International Aero Engines

ENGINE - LP COMPRESSOR - INTRODUCE THE NEW NO.6  
STRUT FAIRING PANEL WITH ROUNDED CORNERS

May.13/99

**V2500-ENG-72-0346**

**Before and after alteration of  
the No.6 strut fairing panel  
Figure 1**

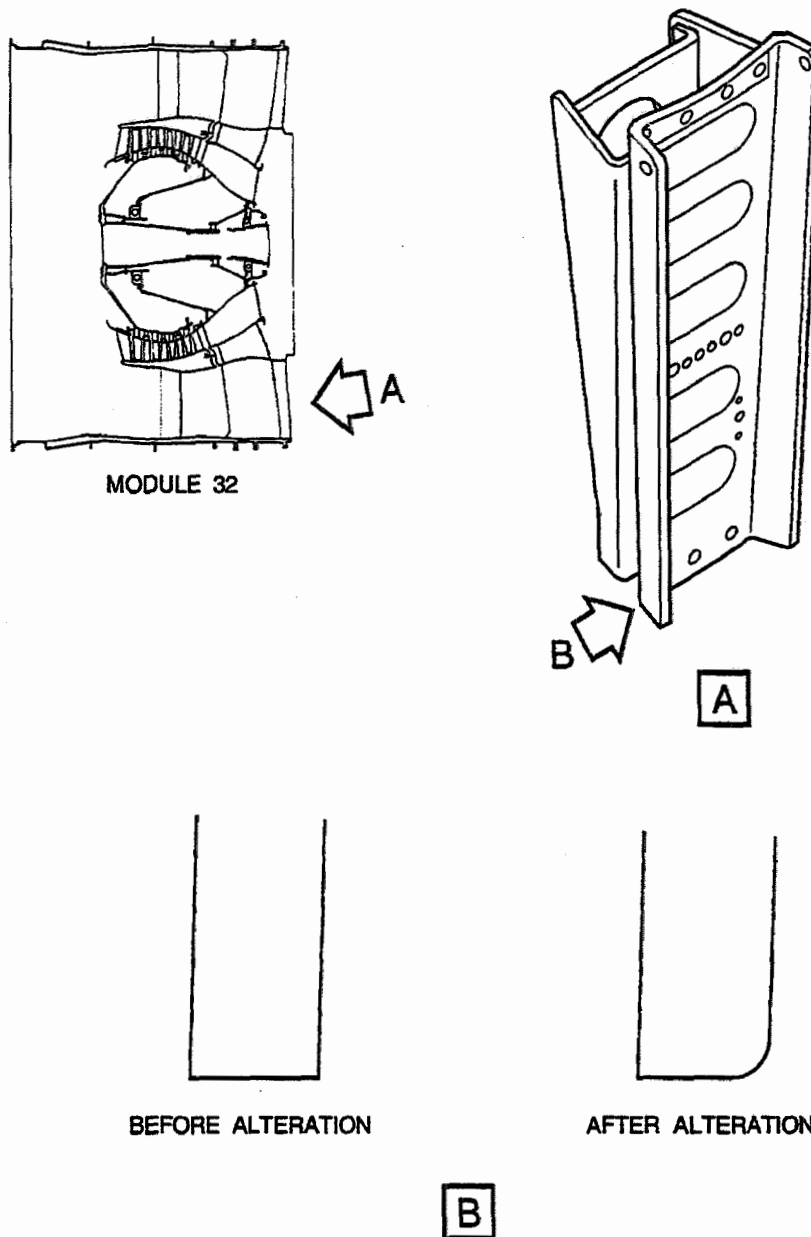
The existing No.6 fairing panel has sharp corners. The sharp corners may cause injury to persons.

(a) The corners of the No.6 strut fairing panel are changed to the round ones (See Figure 1).

To remove the sharp corners.

Cutting of sharp edges of  
the No.6 strut fairing panel  
Figure 2

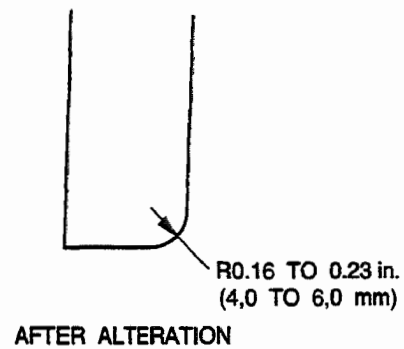
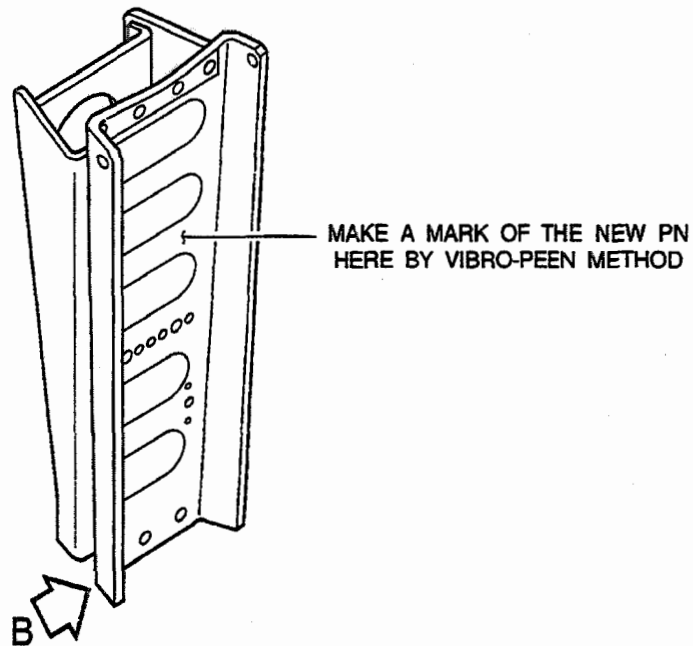
| (a) Set-up and make sure of the shape corners of No.6 strut fairing panel (two positions).   | Refer to Figure 2.  |
| (c) Round off two corners to a radius 0.20in (5,0 mm).   | Use portable grinding of equipment, Refer to Figure 2.  |
| (d) Examine the reworked areas.  | Refer to Figure 2.  |
| (h) Make a mark of the new part No. on the No.6 strut fairing panel adjacent to the old part No., make a line ( - ) on the old part No. to erase it. | Use the Vibro-Peen method, Refer to Figure 2 and SPM TASK 70-09-00-400-501 marking of parts.  |
